**NOTICE OF FINAL
FINDINGS, CONCLUSIONS AND DECISION OF THE
CITY OF PORTLAND HISTORIC LANDMARKS COMMISSION
ON AN
APPEALED ADMINISTRATIVE DECISION
(Type II Process)**

CASE FILE: LU 18-130462 HRM
LOCATION: 2248 NW Hoyt Street

Site Address: **2248 NW HOYT ST**

C.1

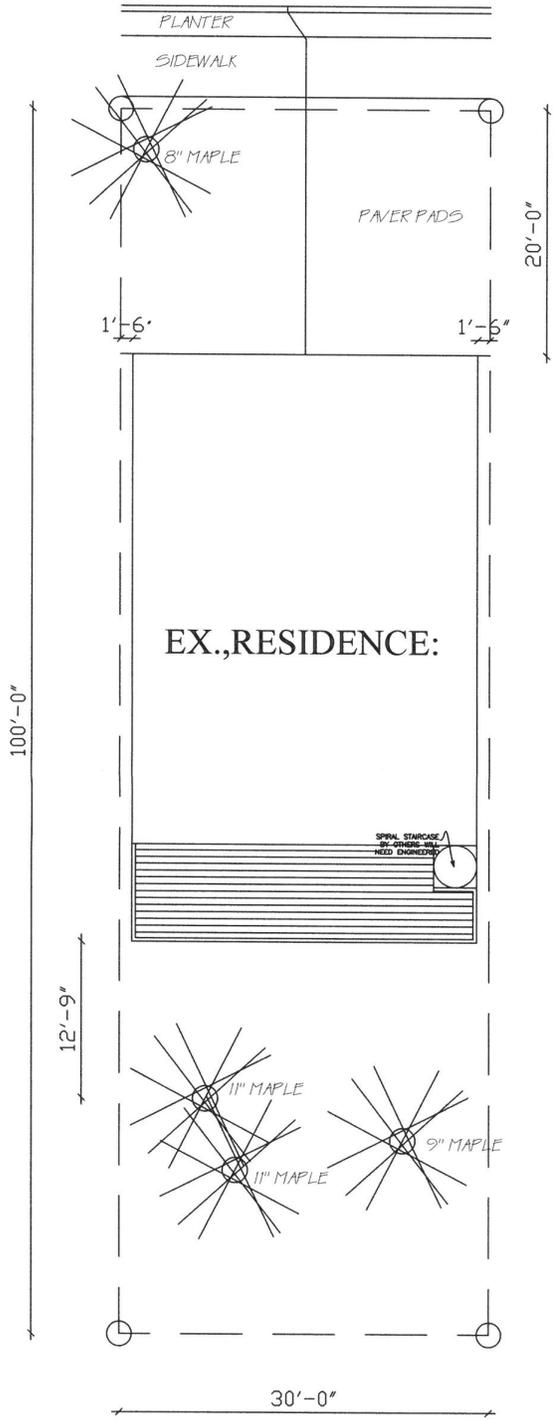
- I. The second story deck shall be a maximum of 5' deep and span a maximum of six feet from the east property line to the west side of the spiral stair.

- J. The attic-level deck shall be a maximum of 5' deep and shall span a maximum of six feet from the east property line to the spiral stair.
- K. No field changes allowed.

PROPOSED REAR ELEVATION

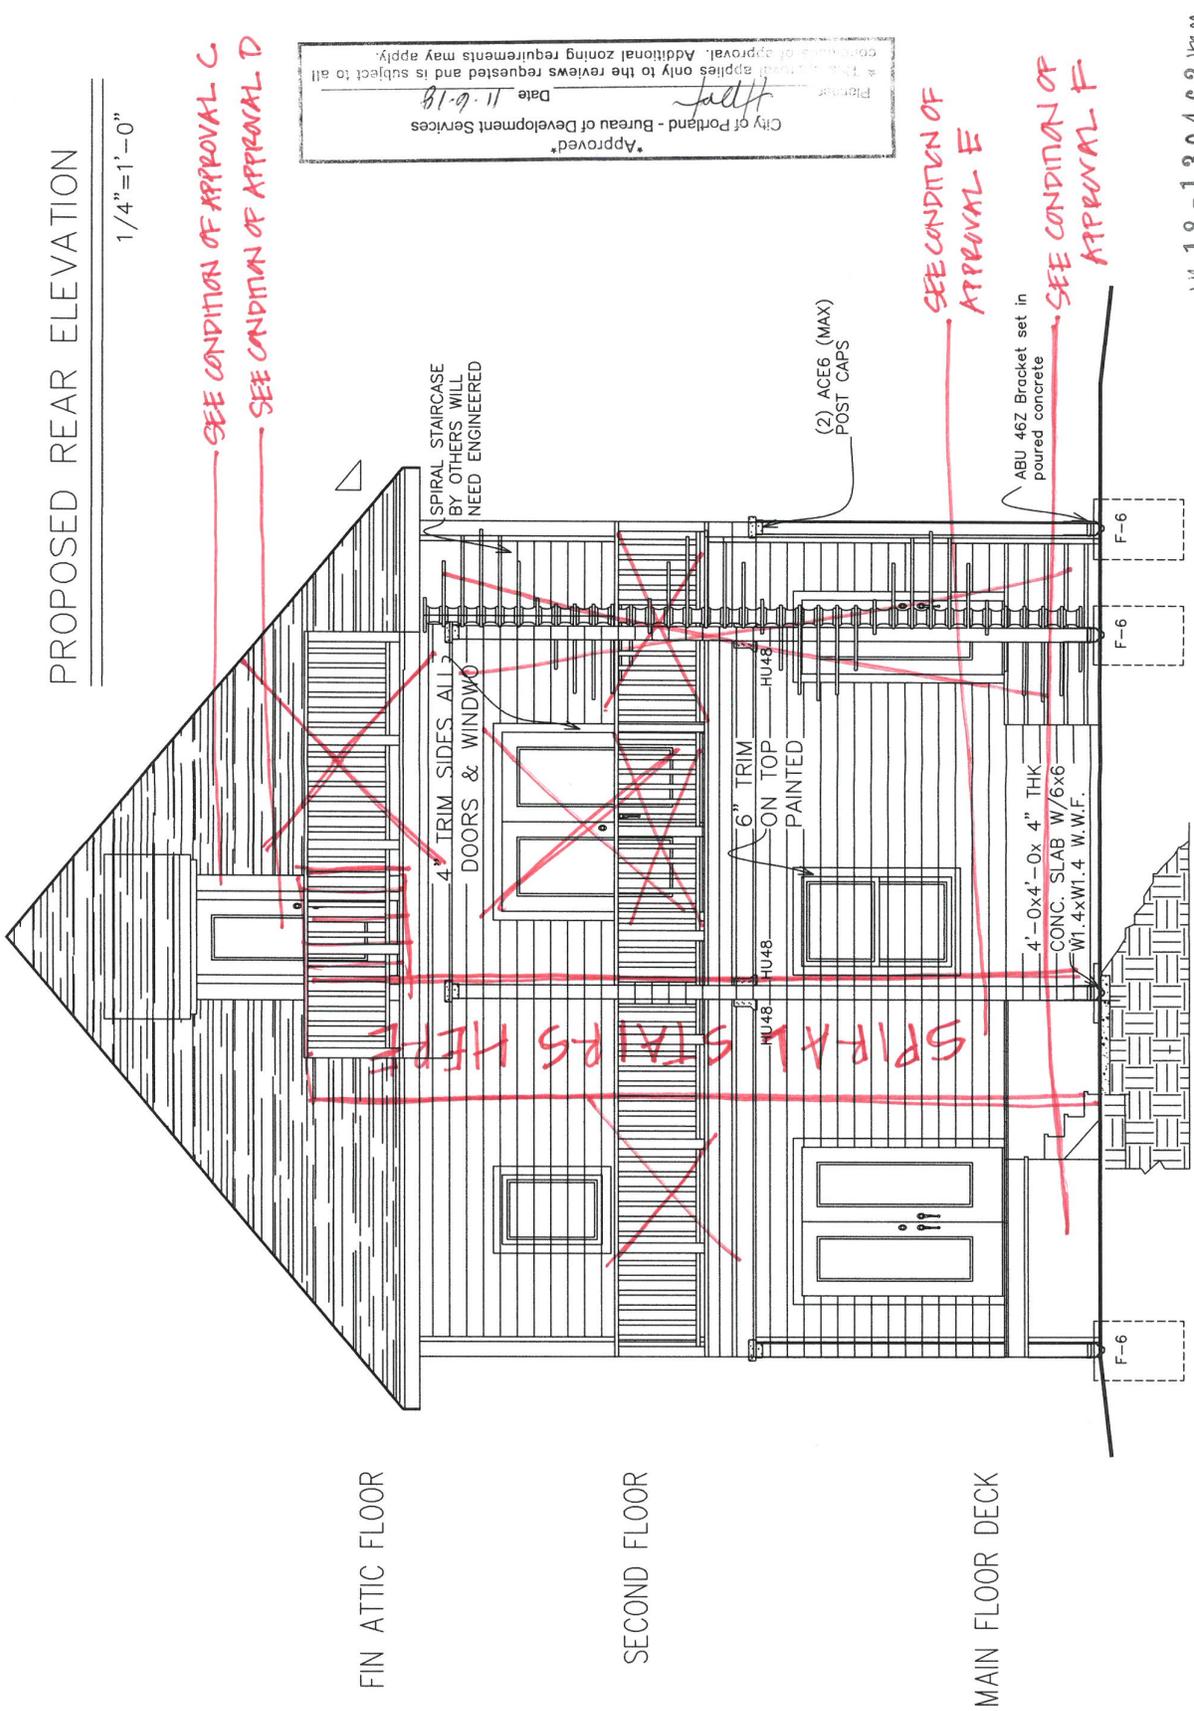
Rather than responding to, and highlighting the architecture of the home, the proposed porches at the second-story and attic-level would obscure the rear façade. The proposed height of the attic-level deck indicates that railings will be required on all four sides, and that the decking will need to be installed in a way that facilitates the continued installation of the existing gutter. To ensure that the railings are compatible in scale, details and character with the existing building, Condition of Approval G states that the existing roof may be cut out only to the width necessary for egress and not for the added deck nor may the roof be used to support railings and that there should be a gap between the deck and the existing eave line.

The porches and associated columns and railings obscure much of the wall plane and remaining original fenestration, and the proposal may necessitate solid fire walls on both the east and west sides from grade to the top of the attic-level railing on the east side, and the second story railing on the west side. Conditions of Approval I and J facilitate usable outdoor living area, consistent with depth of many original front porches in the area, while ensuring that a unified railing system that integrates the spiral stair and eliminates the possible need for fire walls on the east and west side. To ensure that the additions are compatible in scale, color and details with the existing building, Condition of Approval F states that the deck and new porch steps shall be topped with ipe, and that the rim joists and columns shall be trimmed in a painted wood trim board finished to match the trim on the primary resource and Conditions of Approval C and D state that the new attic dormer door shall be wood, surrounded by wood trim.

- E. The spiral stair shall be structurally supported by its center pole, and not structurally supported by the rear wall of the house and shall be located toward the center of the rear elevation, not within the setback.

- G. The existing roof may be cut out only to the width necessary for egress and not for the added deck nor may the roof be used to support railings and that there should be a gap between the deck and the existing eave line.
